STRAWBERRY PARK RESIDENCE
STEAMBOAT SPRINGS
COLORADO

PLAN REVIEW COMMENTS

Job Address: tbd
Applicant: PF Wall, LLC.

Plan Log No. CB-06-438
Designer: CCA

DATE:	REVISIONS:
May 5, 2007

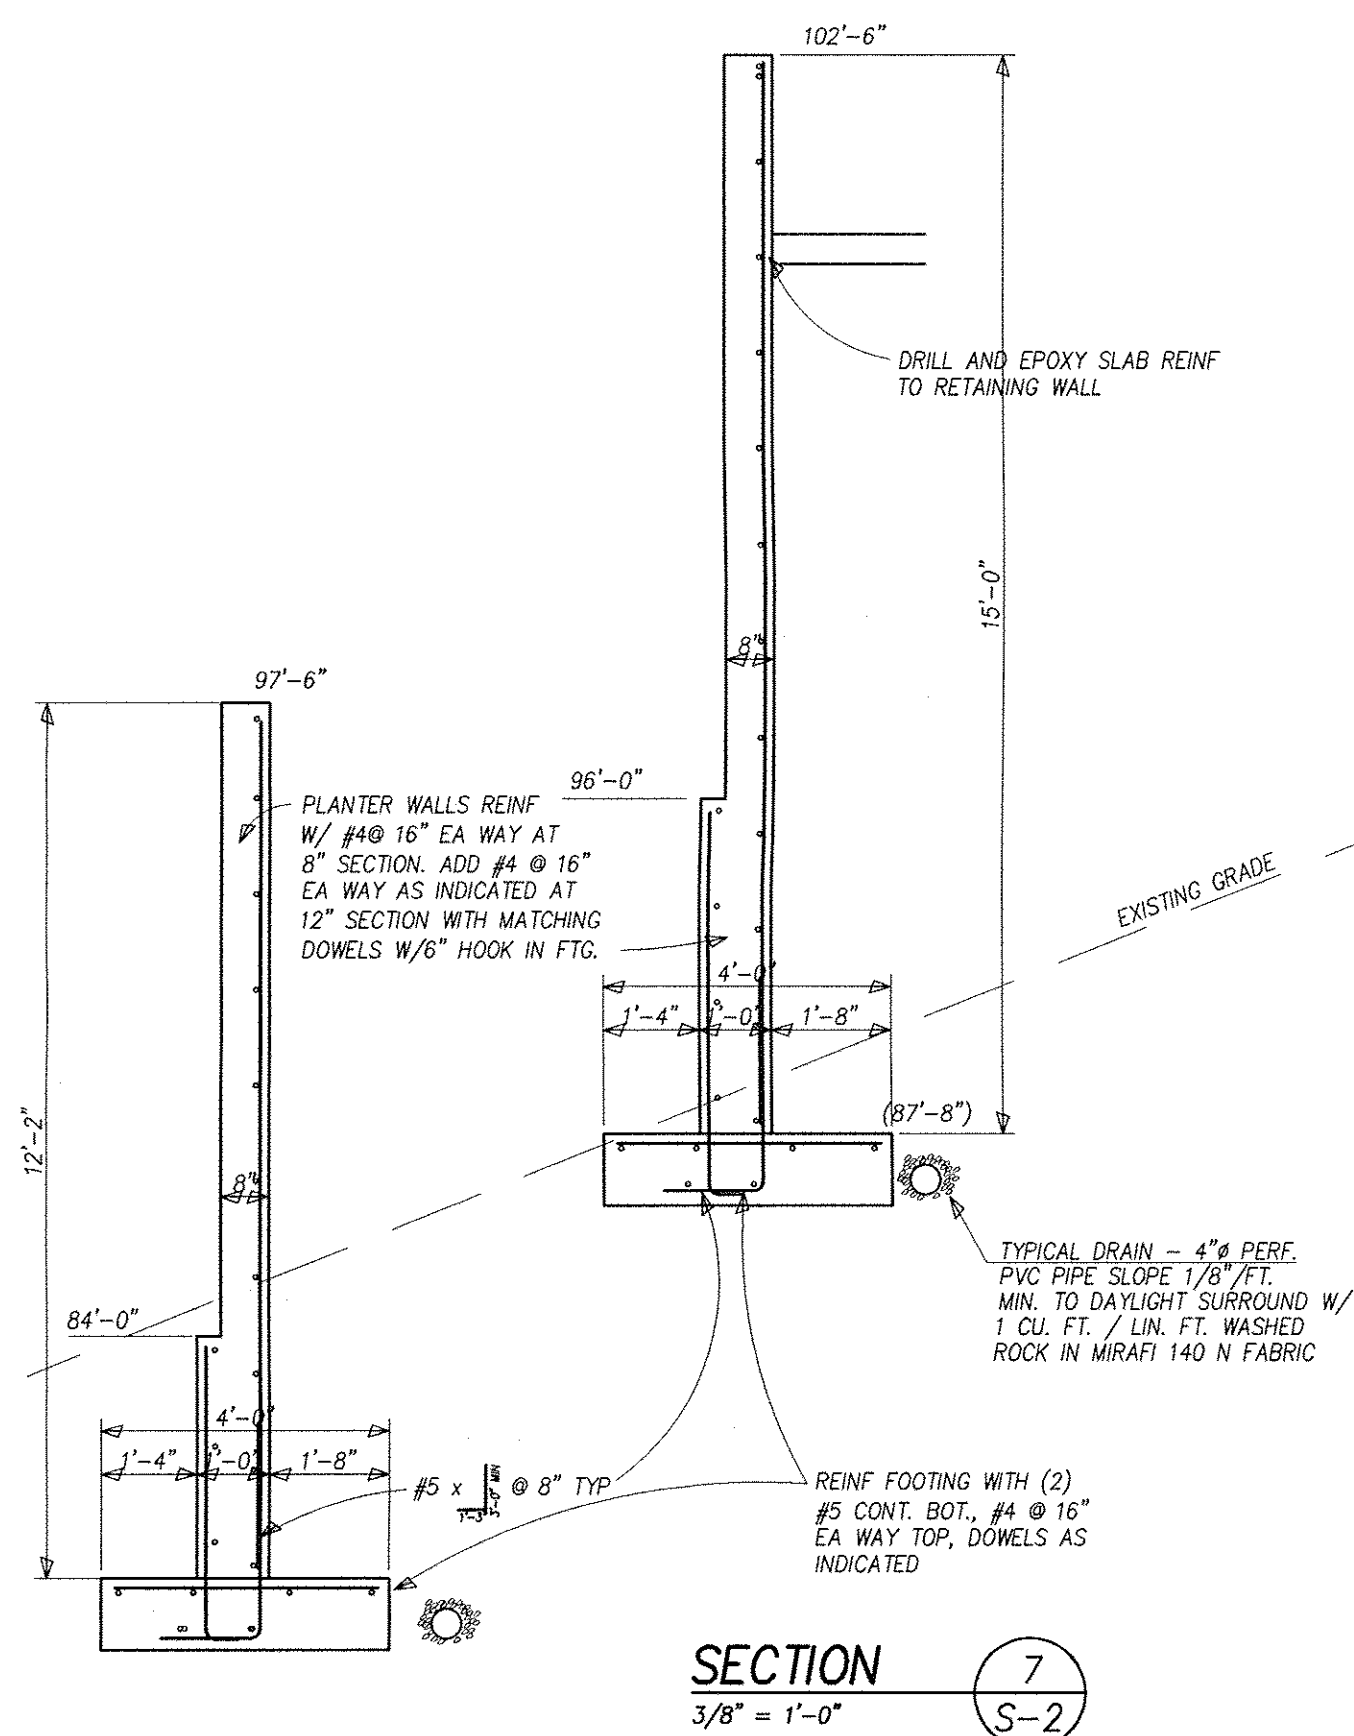
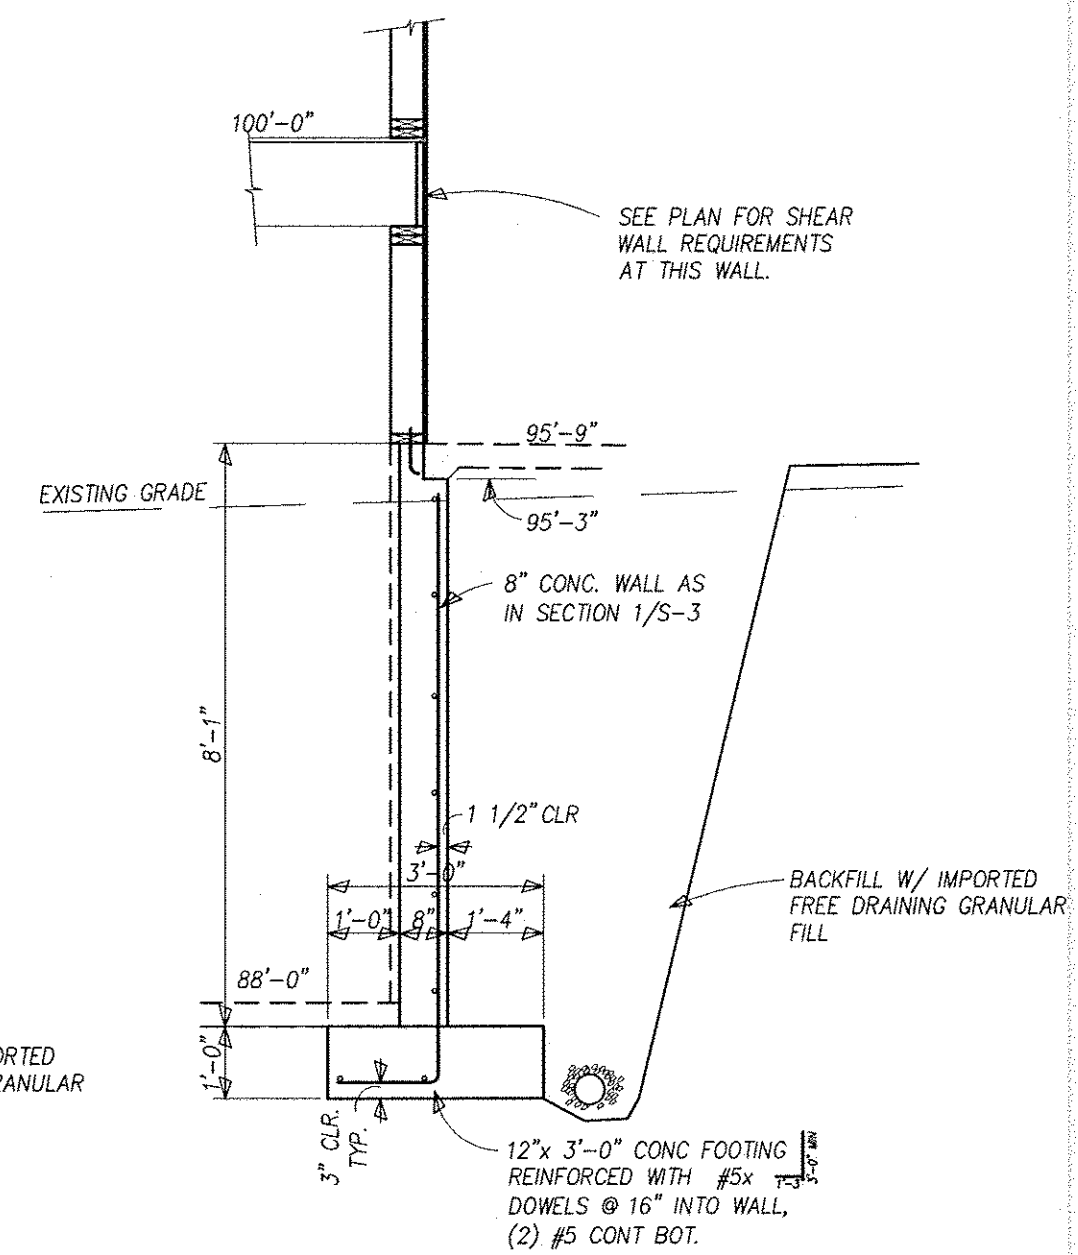
1. Remove the words "Foundation only" for a full permit.
2. Provide an engineered design for retaining walls greater than 4' high. 8/S2.
3. Show how you will provide supply air to the media room.

1. Foundation Only has been removed from the full set of structural drawings issued for full permit.
2. A retaining wall design for walls up to 10 feet has been provided.
3. A note has been added to the plans stating that the media room will receive light and ventilation per code minimums via artificial light and a HRV.
4. The fireplace specified is 5 piece modular conc. unit manufactured by Contempo Fireplaces, Alb, NM—A cut sheet, install manual and manufacturer details are contained in this document. (attached)
5. Manufacturer specs have been attached for the cable rails and details in plan set now reference this Manufacturer.
6. See item 4.
7. Complete structural drawings have been provided.
